DART SERVICE INSTRUCTION

TO AMEND INSTALLATION INSTRUCTIONS: IIN-D206-667 REV. C
REF. CANADIAN STC: SH01-5
REF. FAA STC: SR01304NY

DESIGN		DART AEROSPACE LTD	
DRAWN		HAWKESBURY, ONTARIO, CANADA	
CHECKED		DRAWING NO.	REV. J
MFG. APPR.		DSI 9346	SHEET 2 OF 2
APPROVED		TITLE	SCALE
DE APPR.		DEVIATION ON D206-667 & D407-667	NTS
DATE	10.04.09	COPYRIGHT © 2006 BY DART AEROSPACE LTD	
		THIS DOCUMENT IS PRIVATE AND CONFIDENTIAL, AND IS SUPPLIED ON THE EXPRESS CONDITION THAT IT IS NOT TO BE USED FOR ANY PURPOSE OR COPIED OR COMMUNICATED TO ANY OTHER PERSON WITHOUT WRITTEN PERMISSION FROM DART AEROSPACE LTD.

FIGURE 1 - INSTALLATION OF DART CROSSTUBES ON BHT/AAI SKIDTUBE

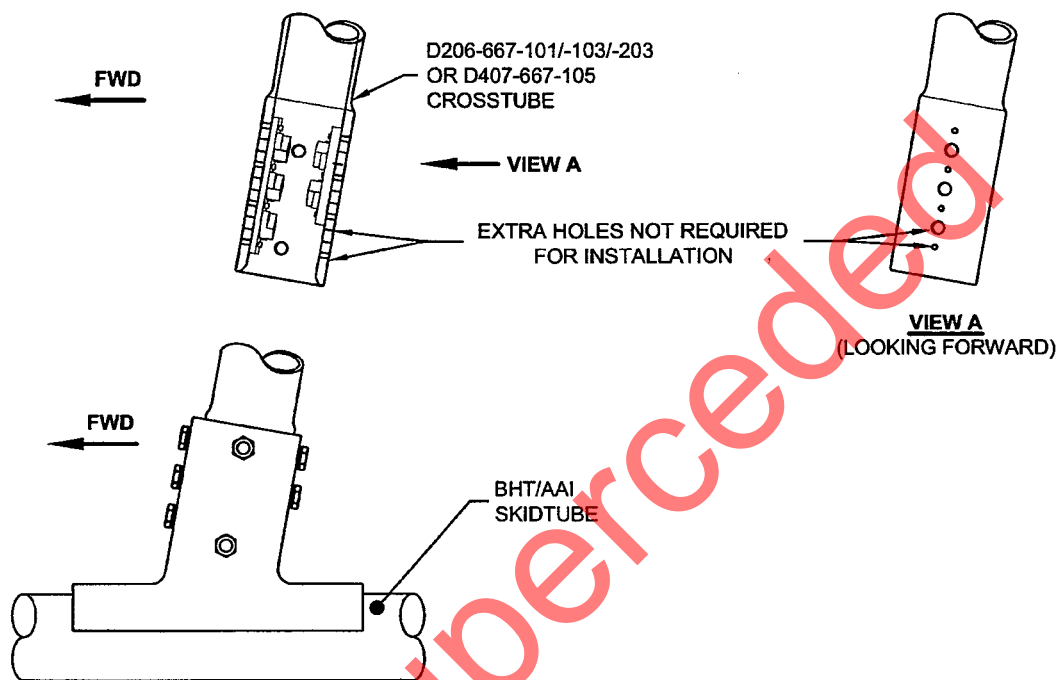
THE FOLLOWING D206-667-101/-103/-203 AND D407-667-105 CROSSTUBES HAVE EXTRA HOLES DRILLED ON THE AFT SIDE OF THE CUFFS. THIS HOLE IS NOT REQUIRED FOR INSTALLATION OF DART CROSSTUBES ONTO BHT/AAI SKIDTUBES AS SHOWN IN FIGURE 1.

CUSTOMERS RECEIVING CROSSTUBES AT CHG 002 PRIOR TO 06.08.08 SHOULD CONTACT DART FOR DISPOSITION IF INSTALLING THE DART CROSSTUBES ONTO BHT/AAI SKIDTUBES PER IIN-D206-667 REV. C.

CUSTOMERS RECEIVING CROSSTUBES AT CHG 002 PRIOR TO 06.08.08 TO BE INSTALLED WITH DART SKIDTUBES MAY FIND THAT THE SUPPORTS HAVE BEEN INSTALLED BACKWARDS. THE SUPPORTS SHOULD BE REMOVED AND RE-INSTALLED PER ICA-D206-667.
